YARRA CITY COUNCIL
Internal Development Approvals Committee
Agenda

1.1 PLN15/0783 - 8 Hunter Street, Richmond - Development of the land for two, three-storey dwellings.

TO: Patrick Sutton (Statutory Planning)
 FROM: Hayley McNicol (Urban Design)
 DATE: 25 August 2016
 SUBJECT: 8 Hunter Street, Richmond 3121
 APPLICATION NO: PLN15/0783
 DESCRIPTION: Development of the land for two three storey dwellings.

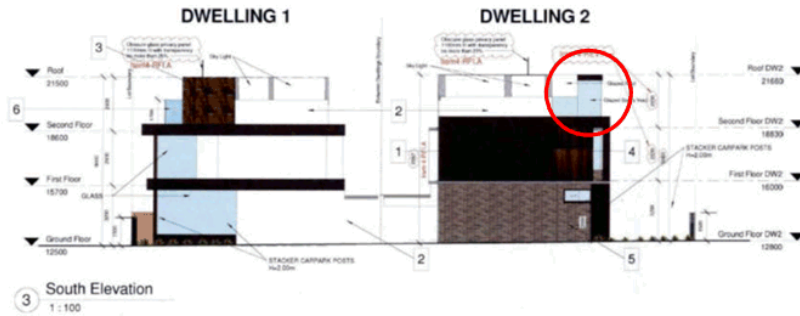
However, Hunter Street is strongly characterised by one and two storey buildings, therefore the proposed three storeys on Hunter Street may have a negative impact on the streetscape, including the heritage buildings to the north. The proposal would benefit from setting back the third storey from the front facade (by approximately 2 metres), to make this storey more recessive. This could be achieved by removing the void structure and setting the roofline back (refer to red circled area below).

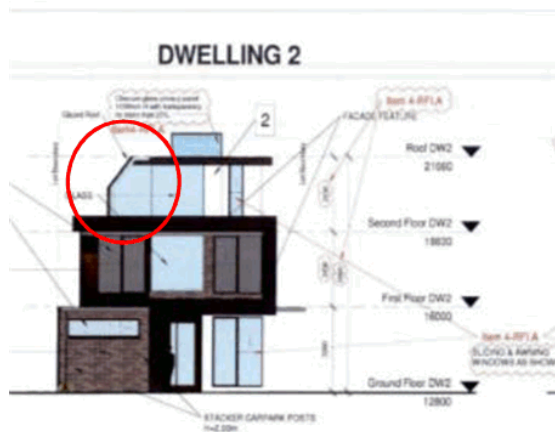
It would be useful for the applicant to provide a section showing the viewline to the building from the opposite side of Hunter Street, to demonstrate that the third storey is adequately recessed. It would also be helpful for the applicant to show the existing buildings in the elevation to illustrate how the proposal sits alongside the single storey building to the south and the double storey heritage building to the north.
